LONDON BOROUGH OF ENFIELD

PLANNING COMMITTEE

Application Number: 17/03651/FUL

PROPOSAL: Subdivision of site and erection of a detached 2-storey 2-bed single family dwelling house at side with vehicular access via Church Hill.

NEW DETACHED HOUSE
 PROPOSED STREET ELEVATION

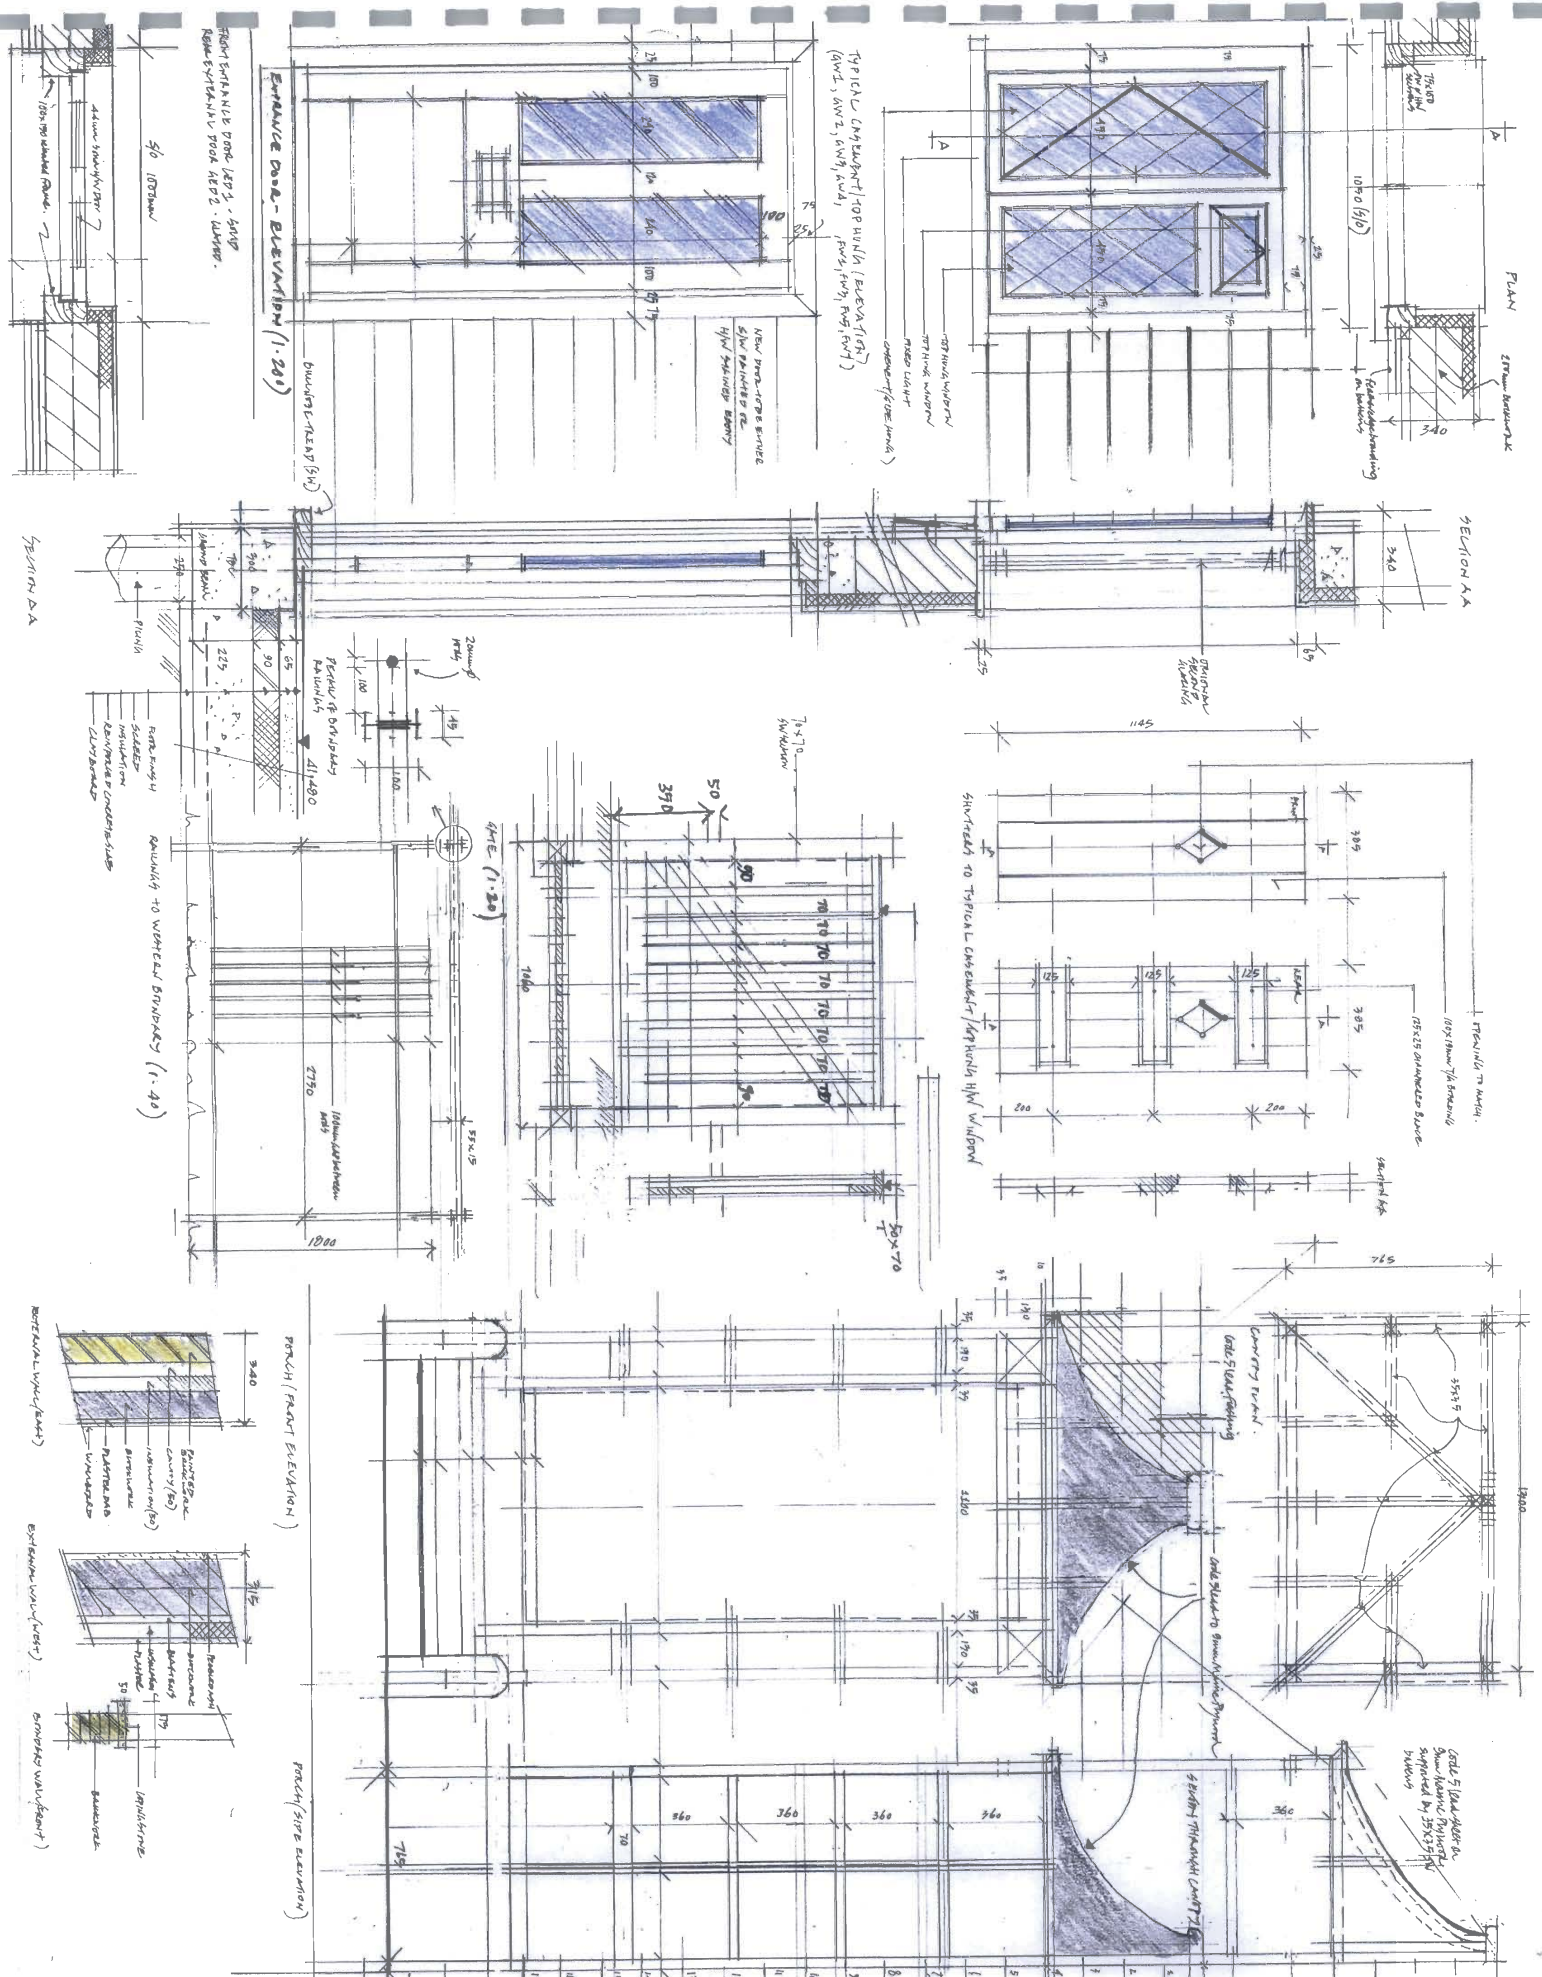
- 6.16. A distinctive characteristic of the existing three Grade II listed cottages is their relationship to one another due to the fall in ground level, with each lower than the adjacent dwelling. The frontage with horizontally constructed weatherboard, formal window arrangements and single roof plane is repeated in each cottage to assist in integrating these three properties into a set of uniformity having a prominent view along Church Hill.

- 6.17. The proposal would result in a fracturing of the curtilage of a listed building materially affecting the setting of a listed building. It is also noted that the proposed new house is designed to replicate the adjacent listed cottages which would also materially affect the setting of a group of listed buildings.

- 6.18. Whilst it is acknowledged that this proposal would provide for additional housing within the borough, it is considered that the principle of the back garden house at this location is not considered acceptable in principle. The proposal plotting a cottage of replicated design of adjacent listed cottage group would be an insensitive development, adversely affecting the setting of the heritage asset and failing to conserve and enhance the character of the conservation area that the council seeks to protect. As such, the development would not be supported.
